BLUE BIRD

**SUBJECT: SERVICE BULLETIN S07MU POWER STEERING RESERVOIR
CAP**

AFFECTED: 2008 MODEL YEAR VISION (BBCV) BUSES

Power Steering Reservoir Cap

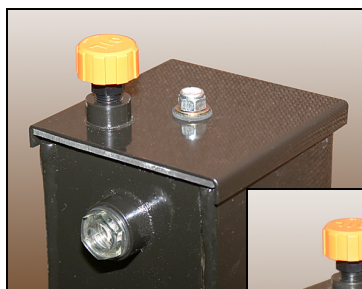
- 1** Park vehicle on a level surface, apply parking brake, turn engine off, remove ignition key and chock wheels.
- 2** Open engine hood and locate Power Steering Reservoir on driver's side frame rail.
- 3** If fluid leakage exist around reservoir cap, clean the area and adjacent components before proceeding.
- 4** Remove and retain Breather from Reservoir Cap.
- 5** Remove and discard retaining nut, flat washer, rubber washer and reservoir cap.
- 6** Check reservoir fluid level. Fluid level should be at the half way point of the site-glass.

CAUTION Do Not Overfill!

Old Design

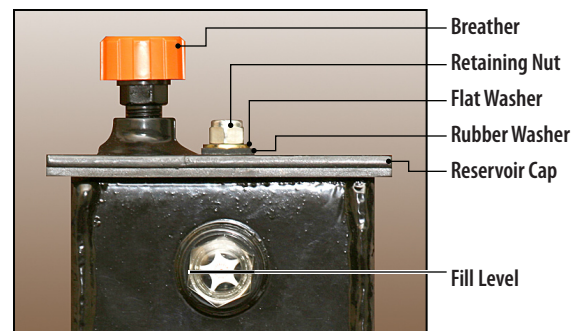
Power Steering Reservoir Cap allows fluid leak.

Replace the existing reservoir cap with the newly designed reservoir cap.

- 8** Install new Reservoir Cap w/gasket, rubber washer, flat washer and retaining nut supplied in kit (Blue Bird Part #0126305). Torque retaining nut to 10 ft. lbs.

CAUTION Do Not apply any type of gasket sealant.

- 9** Install original Breather in new Reservoir Cap.
- 10** Start engine and steer bus full left to full right 5 - 6 times.
- 11** Check Reservoir Cap and Breather to ensure leaks have been resolved.
- 12** Recheck fluid level in site-glass.
